# Evaluation of the Buckling Stress Criteria for the Steel Containment of the Watts Bar Nuclear Reactor

Manuscript Completed: June 1981  
Date Published: November 1982

## **FINAL REPORT**

REVIEW OF TVA'S  
RESPONSES TO QUESTIONS  
SUBMITTED APRIL 9, 1979

FIG 6  
GOVERNING BUCKLING RATIOS

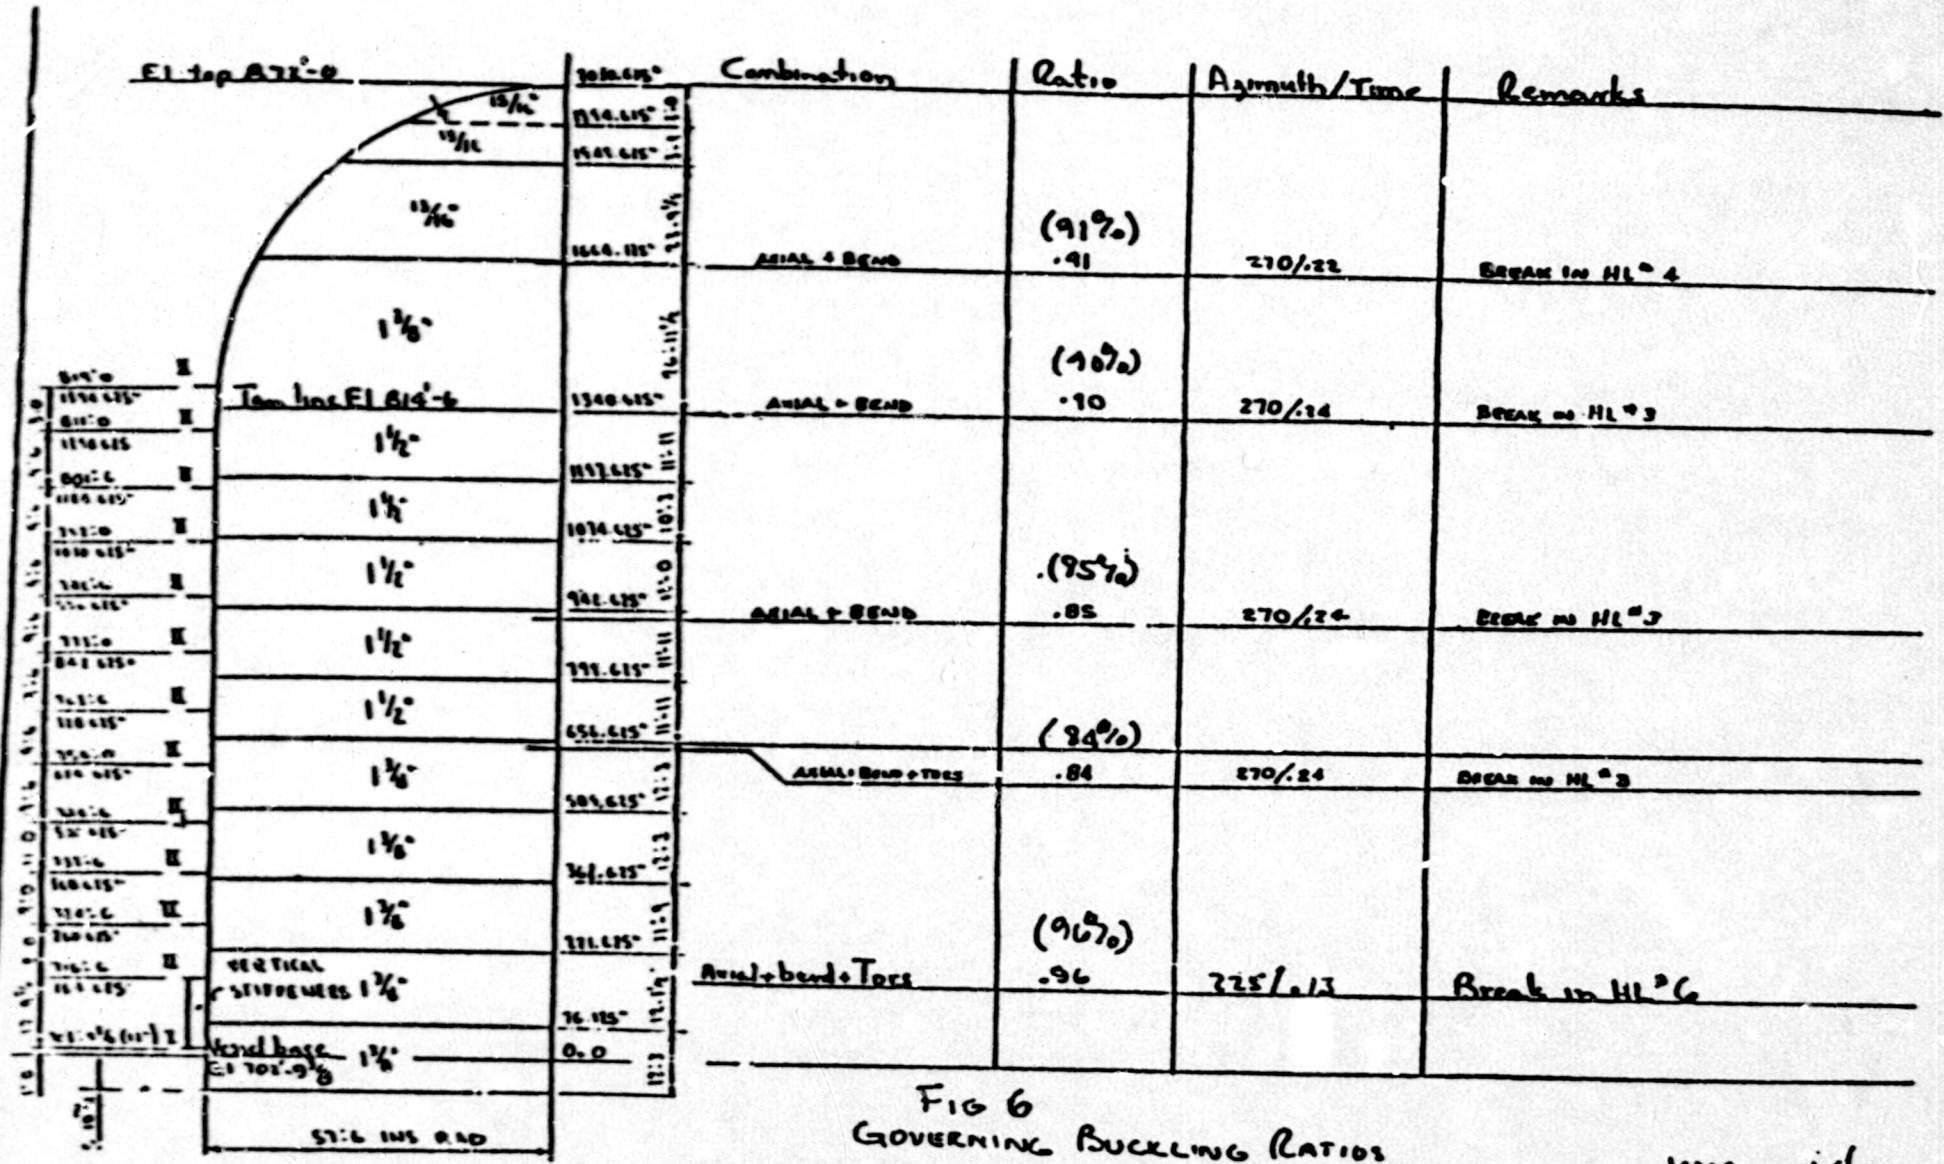
Figure 6 (copy attached) of the response to the original questions shows that the buckling ratios were less than 1 for all areas of the general shell. The additional membrane compressive stresses in the area of the locks and hatch due to the local response of the locks and hatch will be less than or equal to the maximum membrane ( $P_m$ ) "inertial stress" of  $1.6 \text{ k/in}^2$  shown in table 1. Even if this maximum compressive stress is multiplied by a factor of 2, it will still be much less than the incremental allowable buckling stress of  $5.2 \text{ k/in}^2$  ( $14.9 - 9.7$ ) between the local area around the locks and hatch and the general shell. Therefore, the buckling ratio of the shell in the area of the locks and hatch is less than 1 and this area of the containment meets the specification buckling criteria.

FIGURE 3a

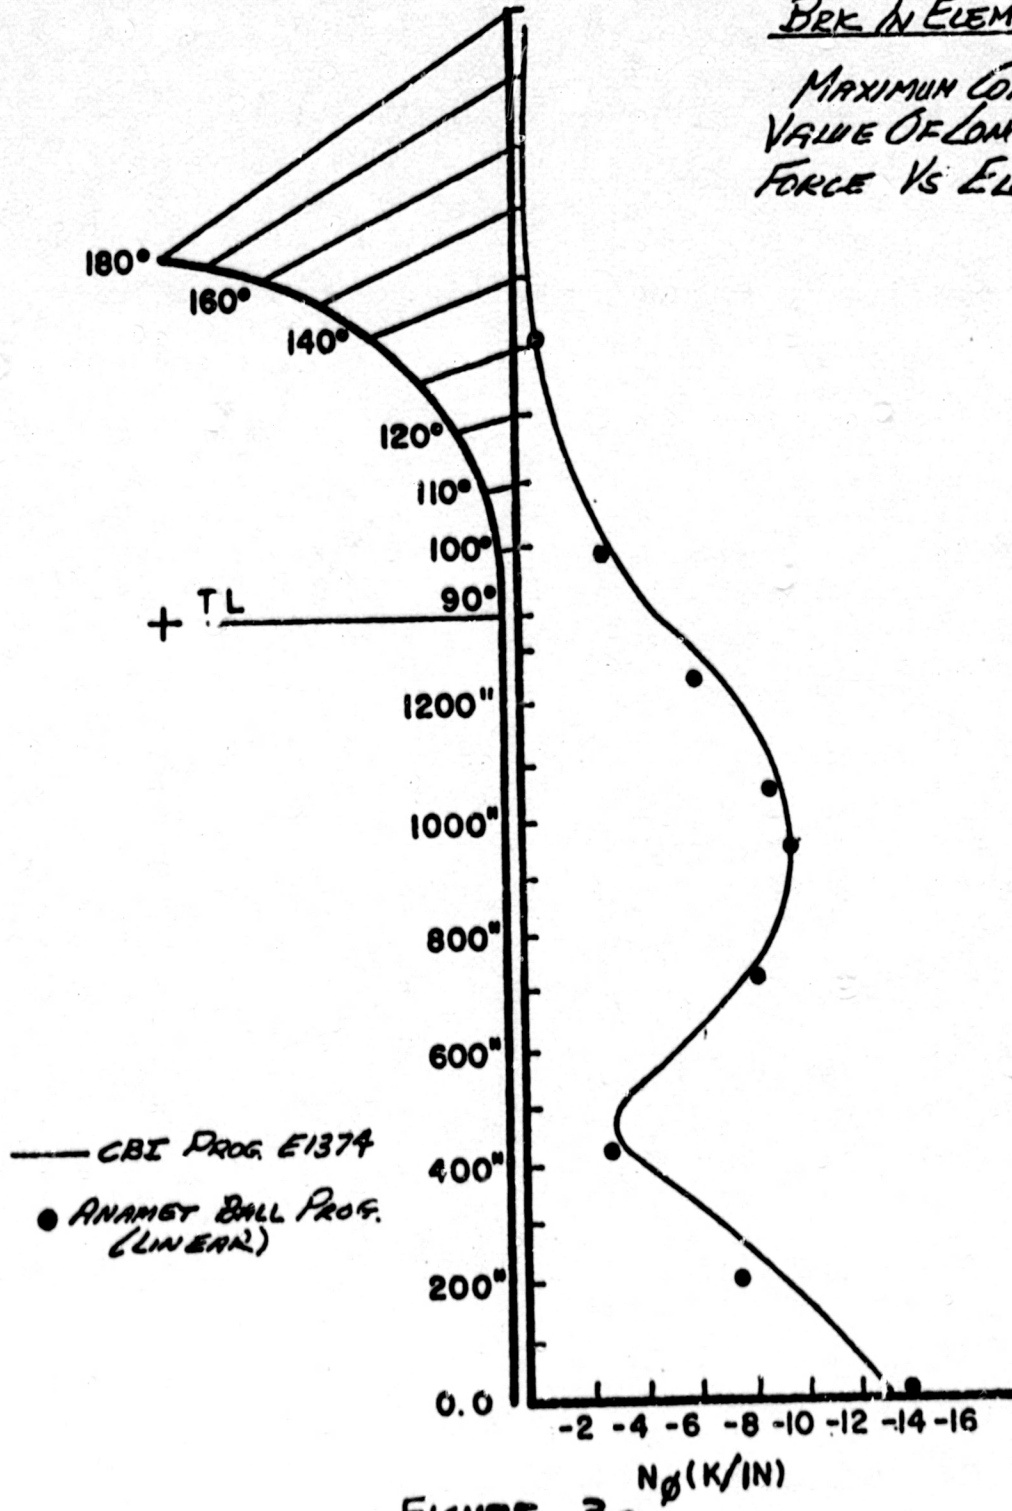
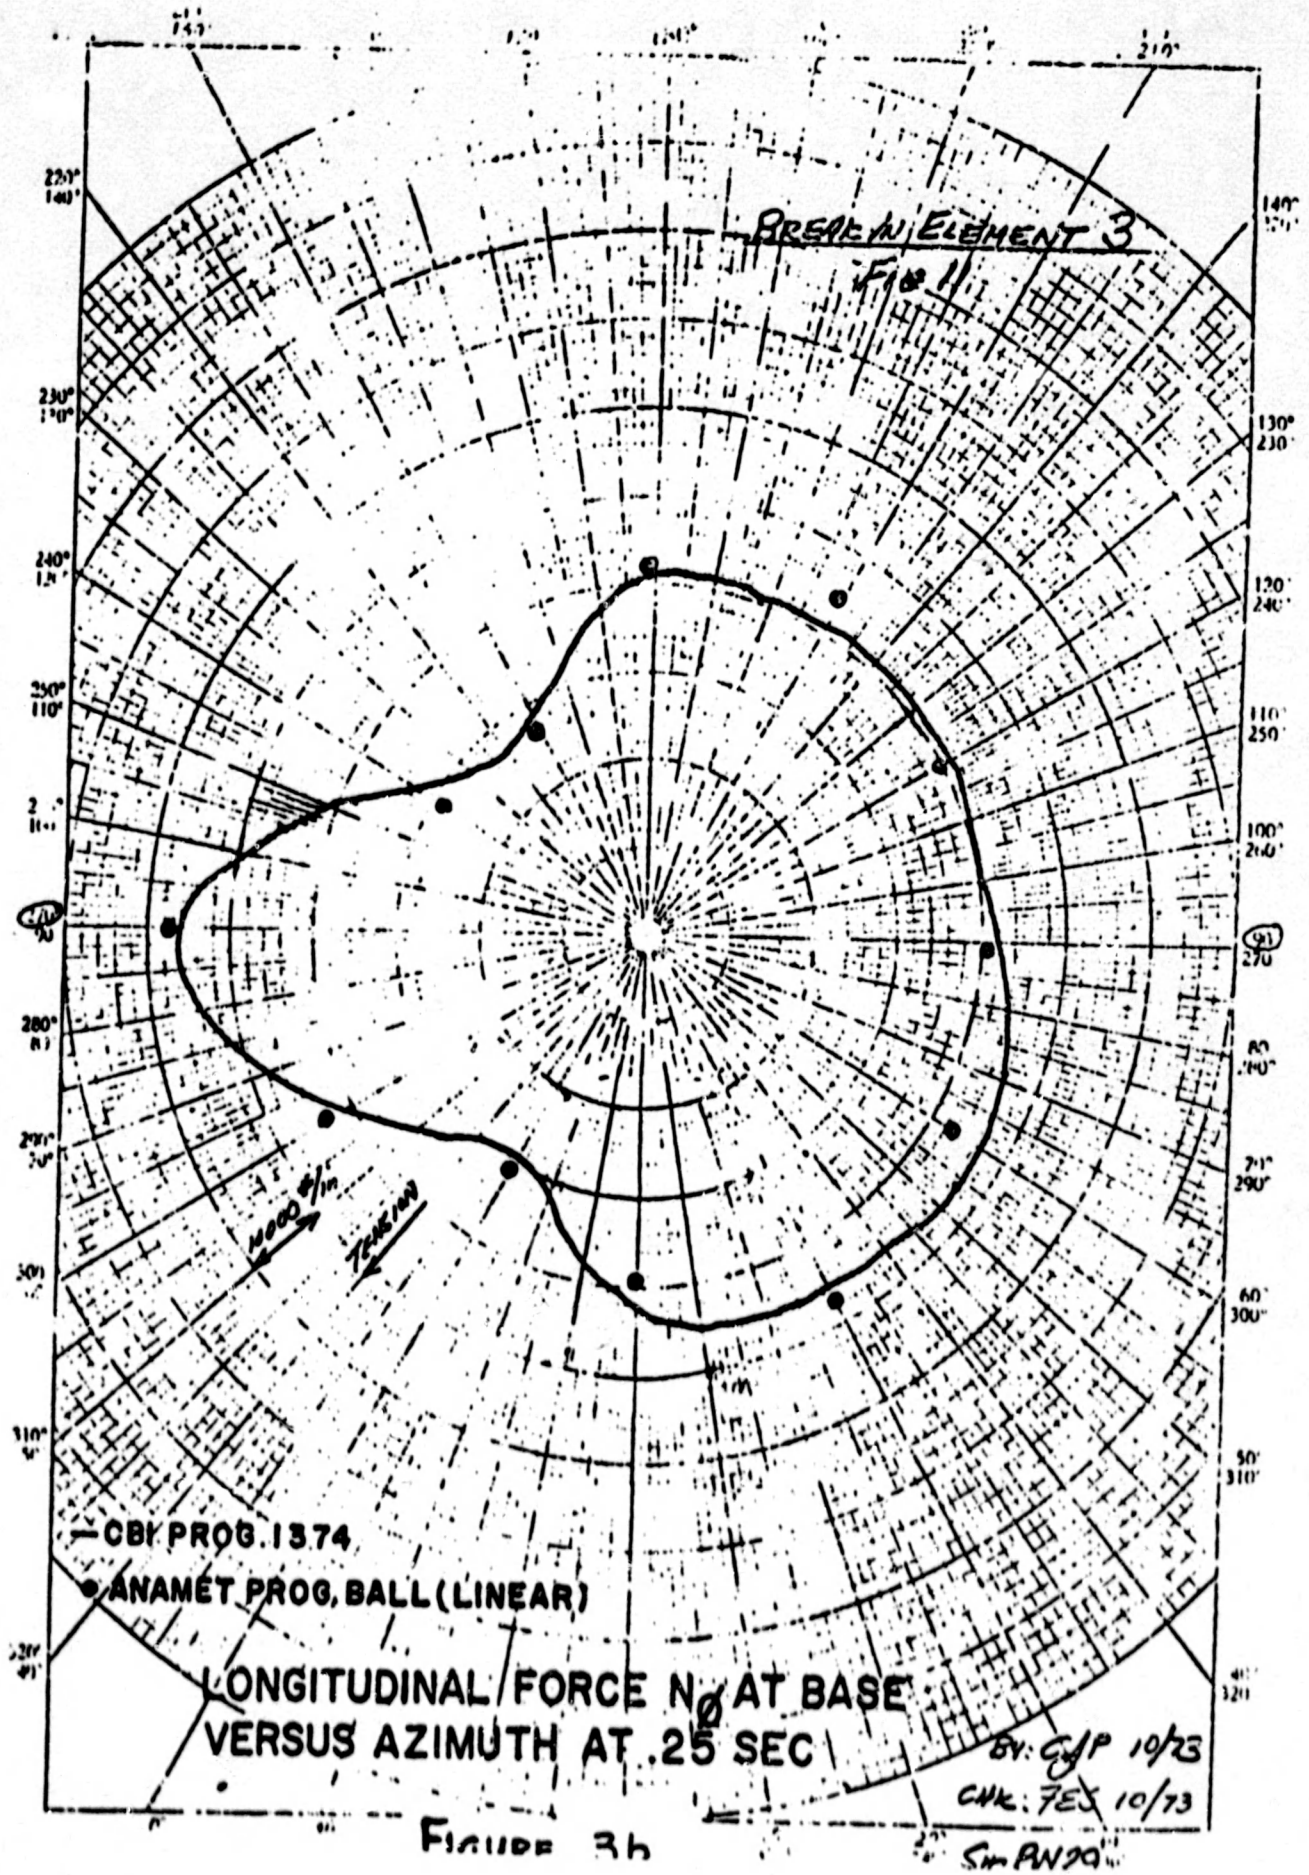
Question 4. Provide a description of the assumptions involved in modeling the containment vessel in order to use the programs identified in Question 3. This description should include a discussion of any convergence and/or accuracy checks that were made.

In addition to the usual convergence and accuracy checks used with shell of revolution models, a completely independent analysis was done by Anamet Laboratories using a completely different computer program and model for one of the specified pressure transients. A comparison of the 1374 results with the Anamet results for a similar vessel geometry is shown in Figures 3a and 3b.

FIG 6  
GOVERNING BUCKLING RATIOS

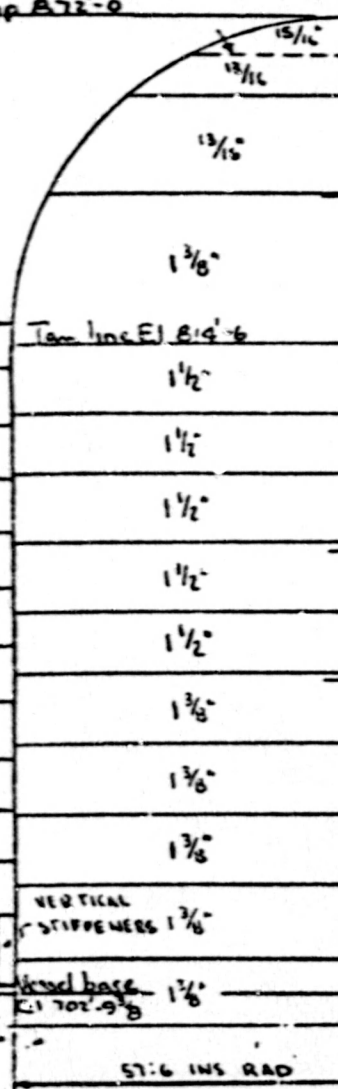
Question 12. Indicate the critical loading combinations which control the design of the steel containment shell with regard to stress intensity and buckling. Identify also the regions and/or regions of the steel containment which was controlled by these critical loadings.

Question 13. Indicate, approximately, the contribution (as a percentage of the allowable stress intensity and allowable buckling loads) of each of the loadings identified in Question 12.

Only those loading combinations with pressure transients (NASPL) govern the shell with regard to stress intensity and/or buckling. See attached Figures 5 and 6 for a summary.

Refer to figures 5 and 6. Percentages are in parenthesis.
